## Conway Planning Commission Staff Report

# I.A REQUEST FOR PRELIMINARY PLAT APPROVAL - WOODLAND COVE PUD

### CITY OF CONWAY PLANNING & DEVELOPMENT DEPARTMENT REVIEW OF WOODLAND COVE PUD PRELIMINARY PLAT

### CITY OF CONWAY PLANNING & DEVELOPMENT DEPARTMENT REVIEW OF TIM FILES PUD PRELIMINARY PLAT

**WOODLAND COVE P.U.D.**  
 CONVEYANCE LOT PLAN  
 SHEET NO. 1 OF 1  
 SCALE 1"=30'  
 DATE 01/03/2018

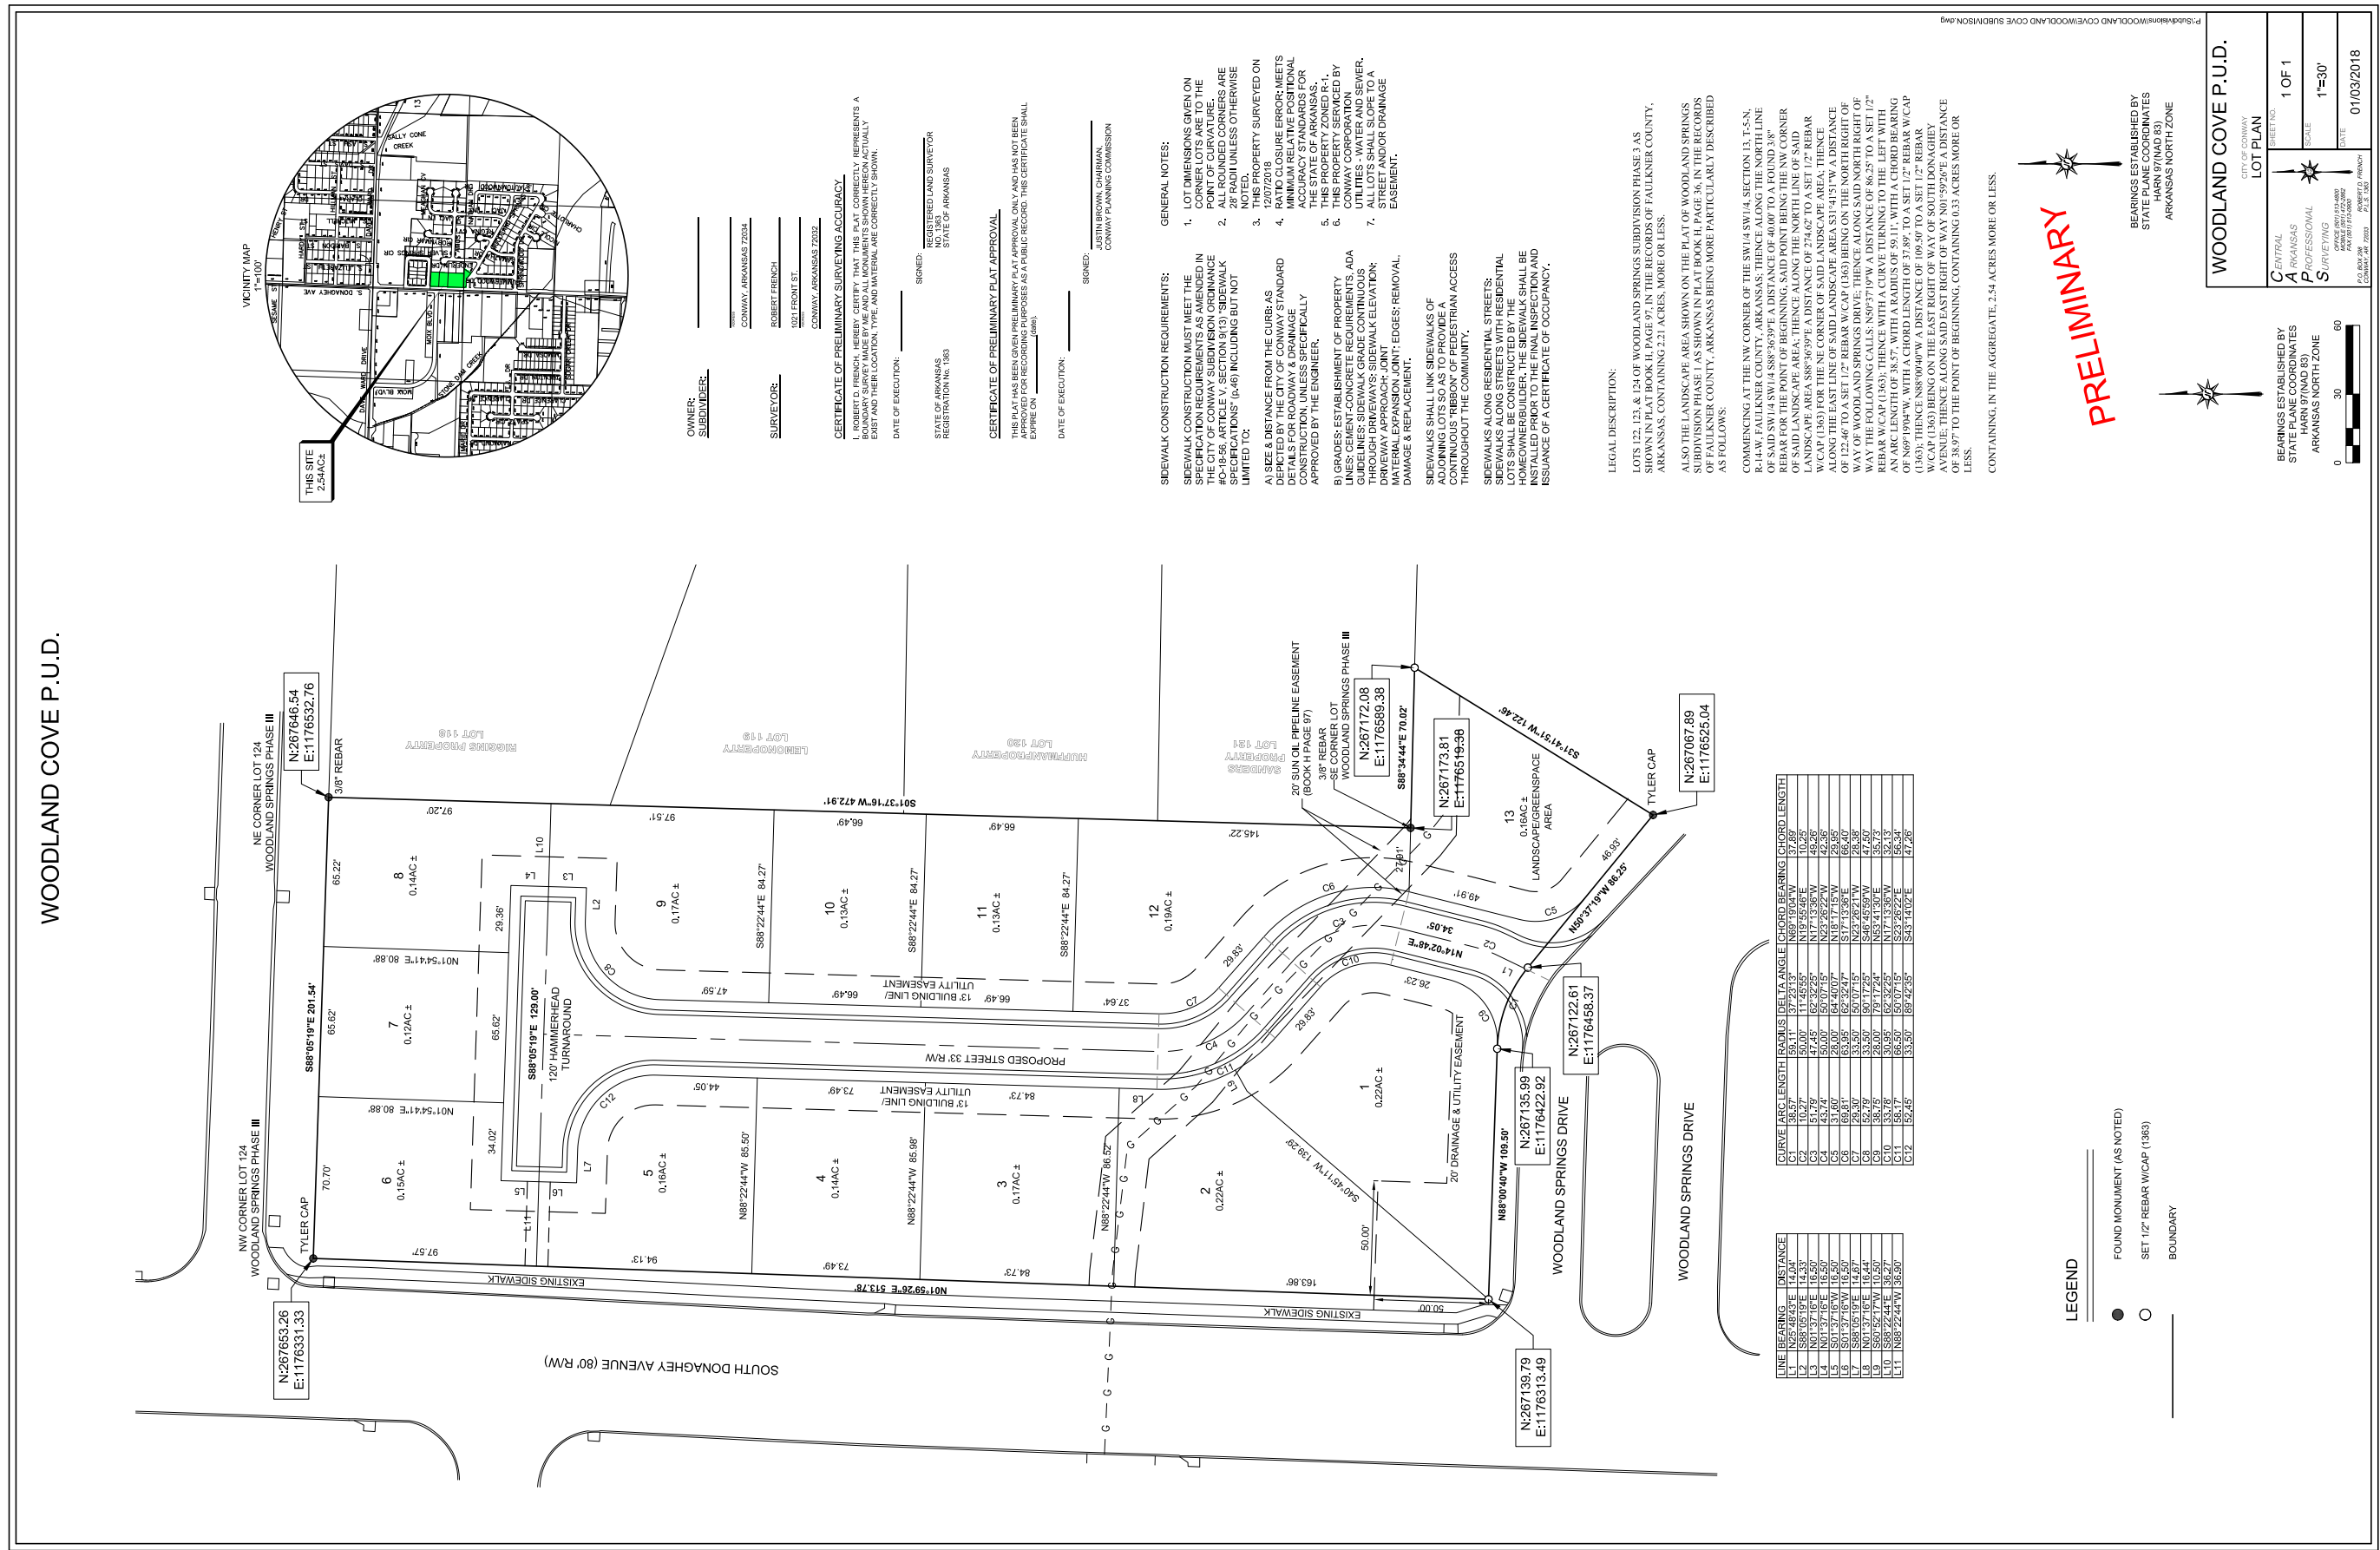
1. Street names that are not similar to existing street names are needed for all proposed streets. Verification by GIS of street names is needed.
2. Show and label all building lines.
3. Label lot 13 as unbuildable.
4. Correct the zoning on plat.
5. Add owner name and address.
6. Label and dimension all sidewalks.
7. Adjust line weight for plat boundary.
8. Label lot number or parcel ID for adjacent properties.
9. Reference CAGIS monument.
10. Show all hydrant locations.

# Tim Files Subdivision (Preliminary Plat)

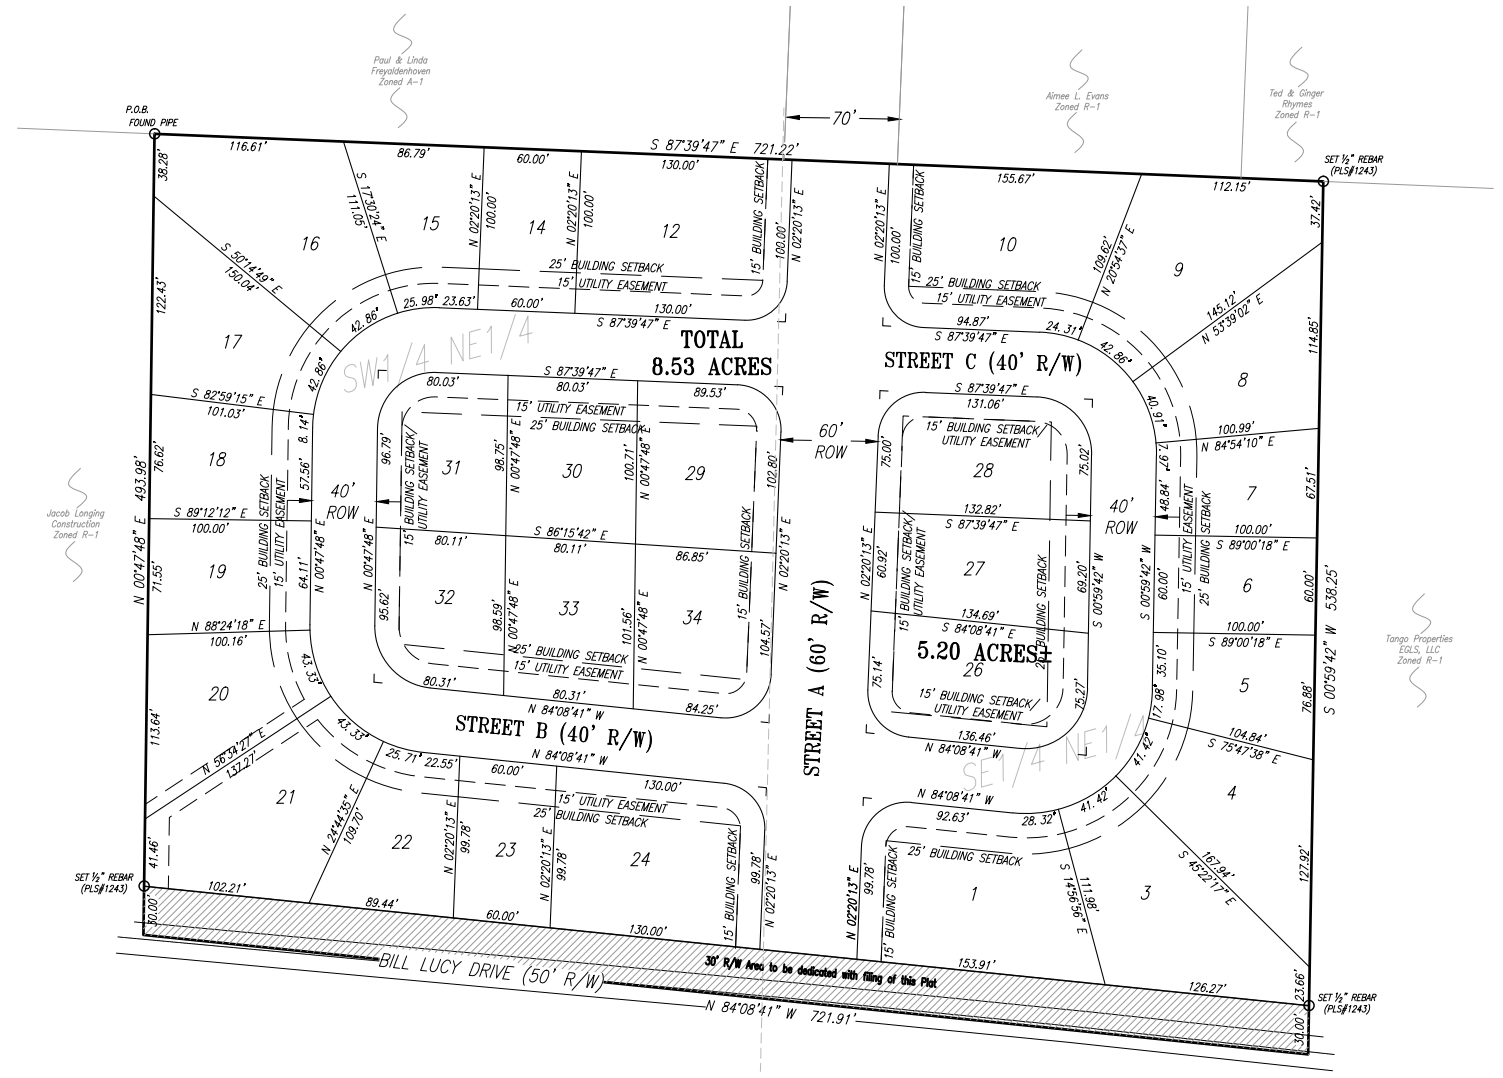
1. Street names that are not similar to existing street names are needed for all proposed streets. Verification by GIS of street names is needed.
2. Correct acreage shown on plat.
3. Correct the zoning on plat.
4. Correct the preliminary plat approval certificate.
5. Label and dimension all sidewalks and planting strip.
6. Show all hydrant locations.
7. Correct Right-of-Way to be dedicated.
8. Remove reference to Miles Crossing in legal description.
9. Separate and number general notes.
10. Add the following to general notes:
  - a. "Every lot must slope to a street or drainage easement."
  - b. "Street Lighting shall be provided I accordance with the standards and spacing prescribed by the Conway Corporation."

11. Add the following to Sidewalk Notes:
  - a. "A five-foot sidewalk and seven-foot planting strip is required along Bill Lucy Drive property frontage and shall be constructed by the developer/subdivider prior to recording of final plat."
